TRANS/WP.29/2004/3  
10 December 2003

PROPOSAL FOR DRAFT SUPPLEMENT 24 TO  
THE 03 SERIES OF AMENDMENTS TO REGULATION No. 37

(Filament lamps)

Transmitted by the Working Party on Lighting and Light-Signalling (GRE)

Sheet H8/1

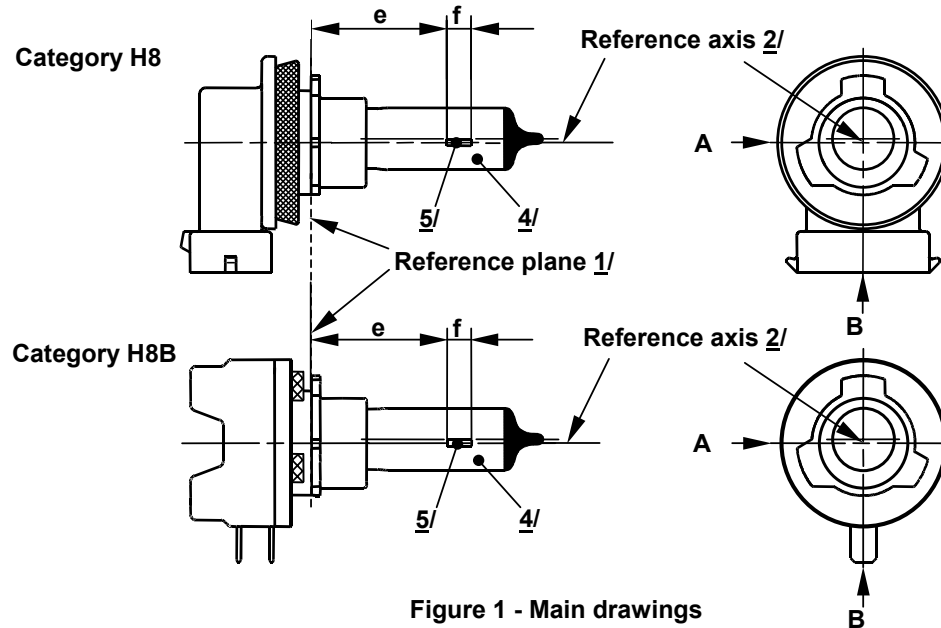
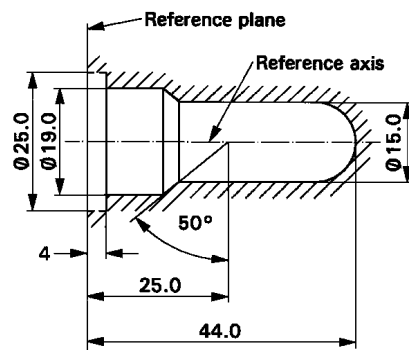
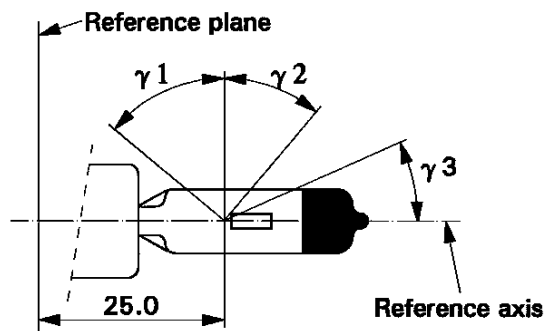
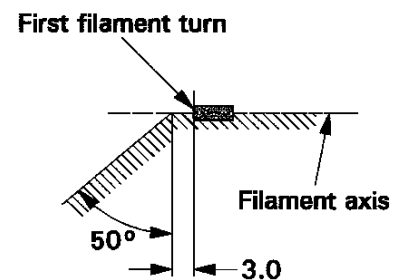
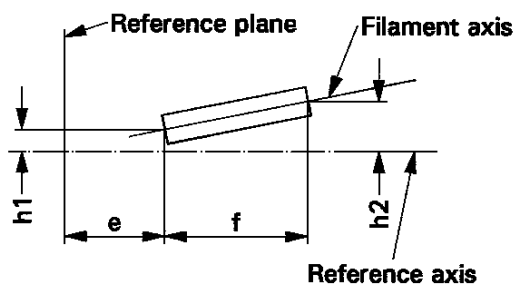
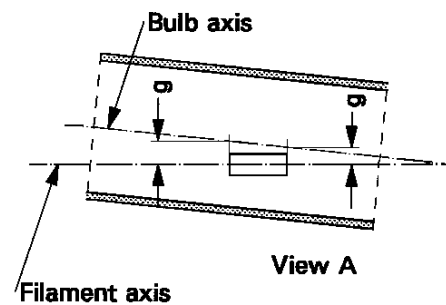
Sheets H8/1 to 4, replace by new sheets H8/1 to 4; (see next pages).

Sheet H9/1

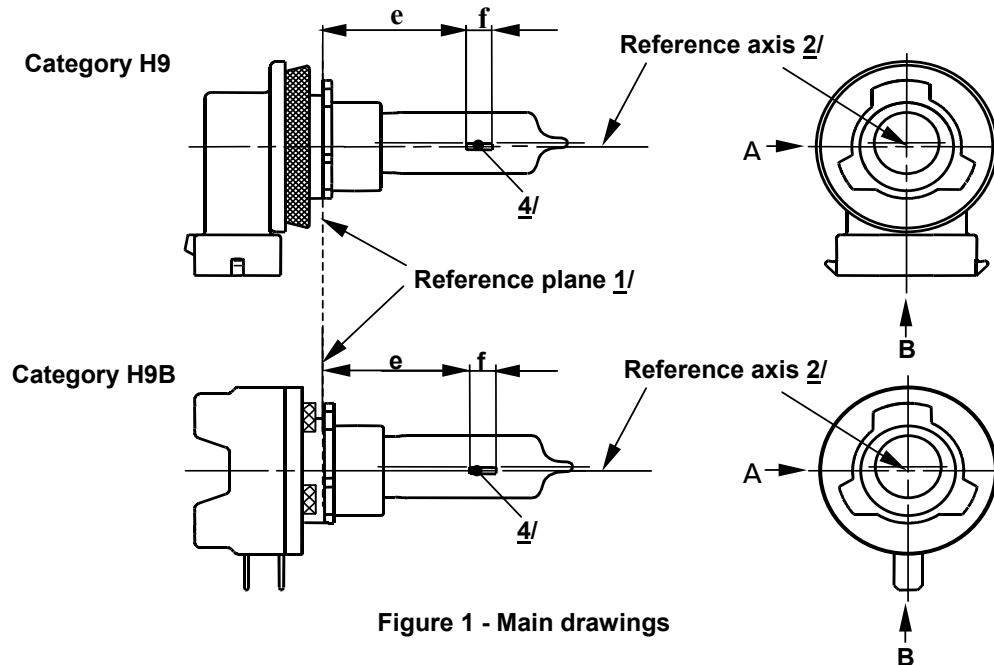
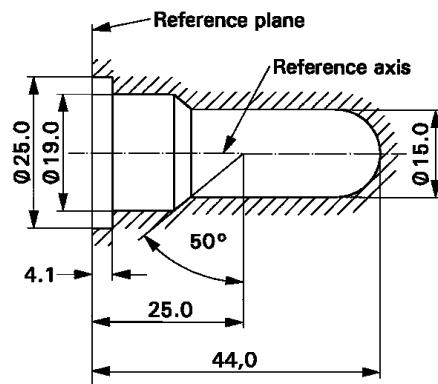
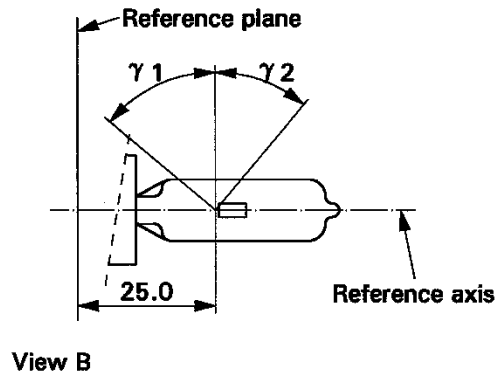
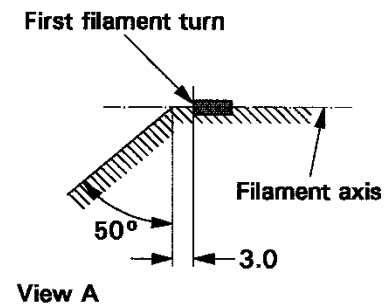
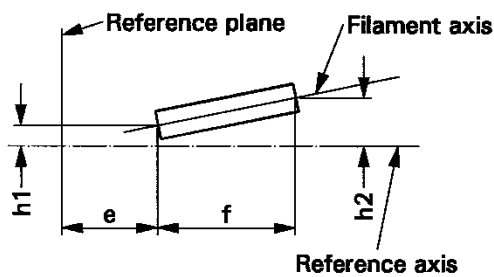
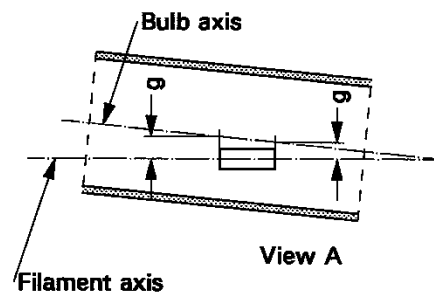
Sheets H9/1 to 4, replace by new sheets H9/1 to 4; (see next pages).

**Sheet H11/1**

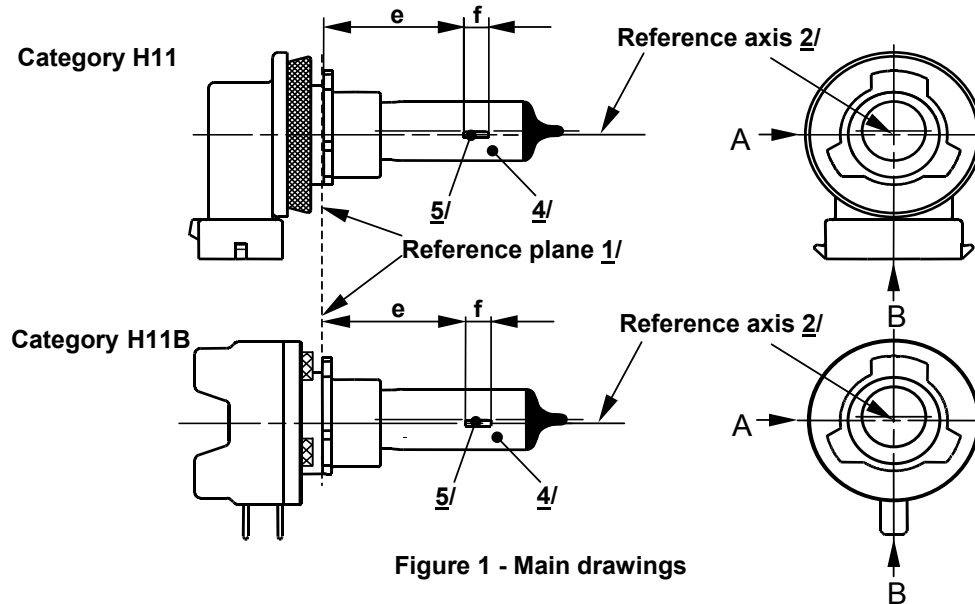
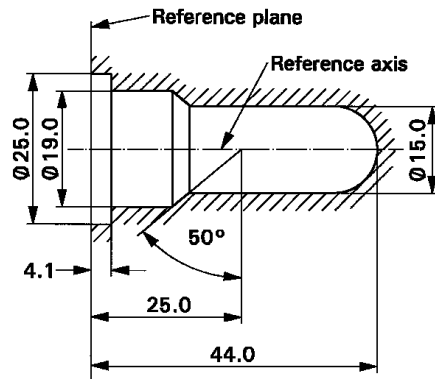
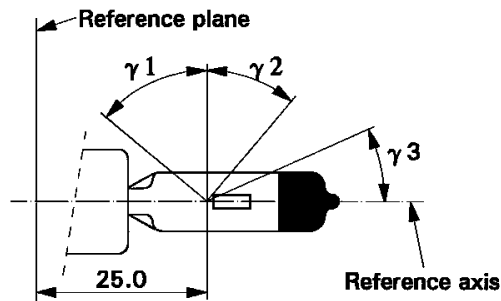
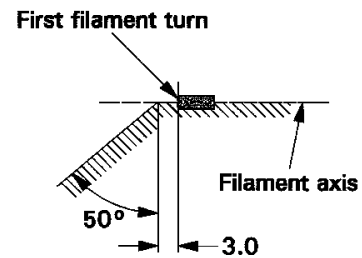
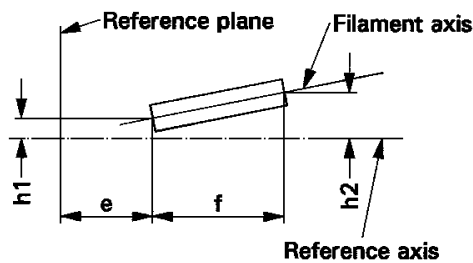
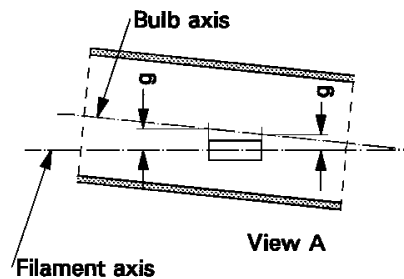
Sheets H11/1 to 4, replace by new sheets H11/1 to 4; (see next pages).

## Sheet HIR2/1

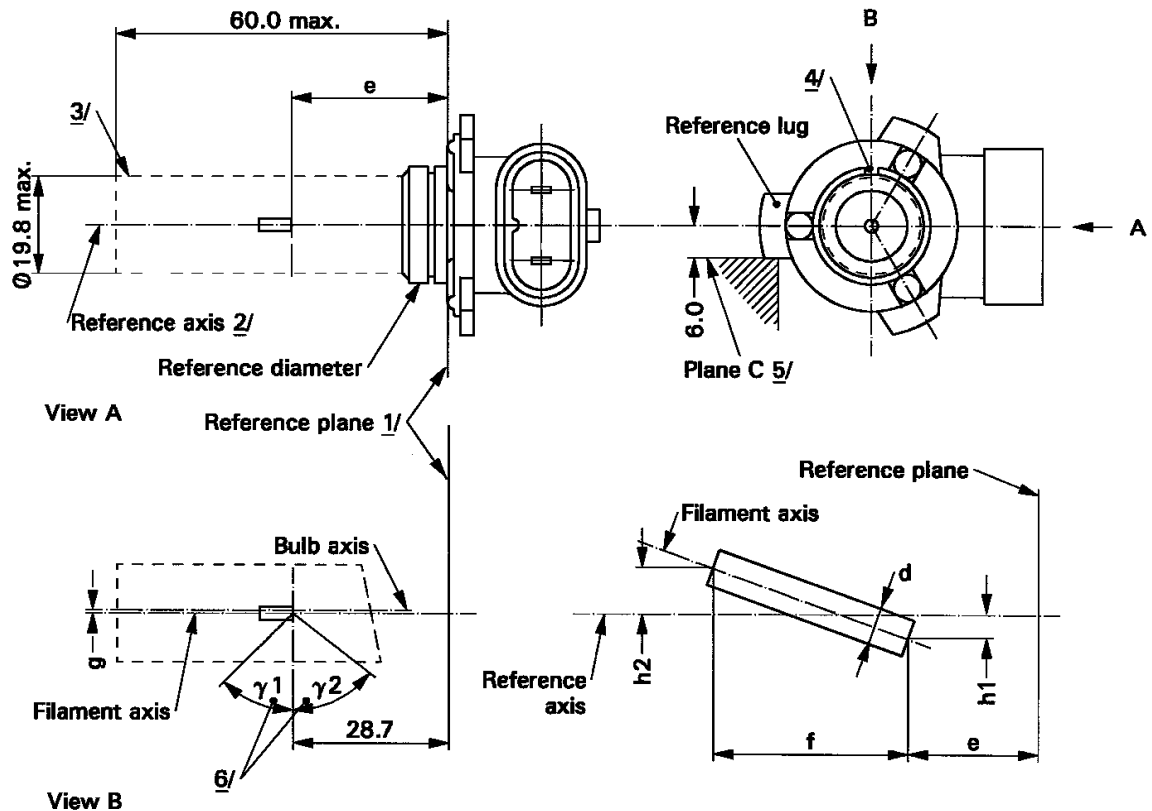
Sheets HIR2/1 to 3, replace by the new sheets HIR2/1 to 3; (see next pages)

Sheet WR21/5W/1

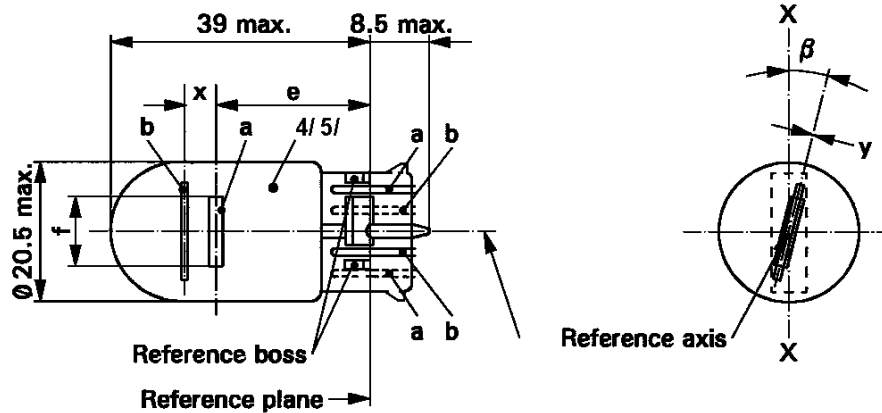
Insert new sheet WR21/5W/1 (between sheet WP21W/2 and sheet WY2.3W/1 as indicated in the list of sheets above), to read: (see next pages).
